Access Compliance Report

Public Rights-of-Way

(Curb Ramps)

Intersection ID: 12305	Main Street: E_5TH_ST	Cross Street: N_COLLEGE_ST	Location: S
ADA ID: 9E49D0837665	Ramp Type: BlendTrans1	Initial Pass/Fail: Pass	Overall Compliance: No
Severity Score: 0			
Codes/Mitigation Info/Possible Solution		Field Measurements/Component Compliance

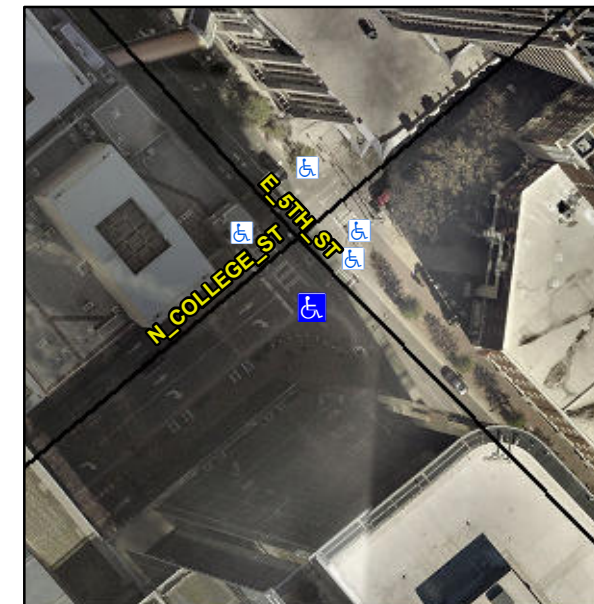
Not Found, R304.5.3

Yes	Ramp inside XWalk1?	Yes	Yes	Ramp inside XWalk2?	Yes
	Road Slope (%)	2.3		Clear Space?	Yes
	Road X Slope (%)	2.4	No	Clear Space to XWalk (in)	24.0
Yes	Any Obstructions?	No	Yes	Storm Grate/Utility Hazard?	No
	Obstruction Type			Storm Grate/Utility Type	
		N/A			N/A
			Yes	Surface Condition? (G/P)	Good
			No	Curb Slope (%)	8.1

Remove & Replace Curb Ramp With Two New Directional Ramps or Equivalent. Restripe Crosswalk(s) To Provide Clear space.
